FIELD SERVICE BULLETIN

FSB Number: LVCCFSB2004-128
Author: Max Dekirmandjian
Date: June 9, 2004
Total No. of Pages: 2
Subject: C650 No Camera Function
Model Affected: C650
Level of Repair: 2

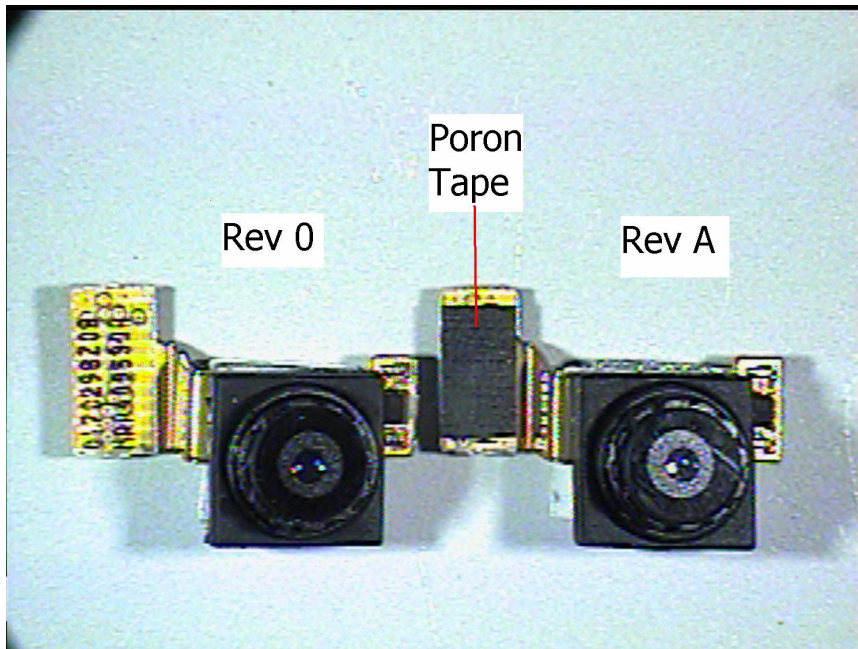
A redesigned camera module has been implemented in production units. The part number 0170298Z08 changes from a Rev 0 to Rev A. This Rev A module has two modifications from the original design:

1) A poron tape has been added to the top of the module to PCB connector.
Refer to the photo below to aid in distinguishing between the Rev 0 and Rev A camera modules:

2) In addition, the soft poron tape under the module has been changed to hard acrylic.

- 1) Disassemble the unit to gain access to the camera module;
- 2) Verify that the module has the poron tape installed on the camera flex as shown in the above photo. Replace with a Rev A module if necessary.
- 3) Reassemble the unit and test camera operation.

Purge Camera Module 0170298Z08 Rev 0 and restock with Rev A.
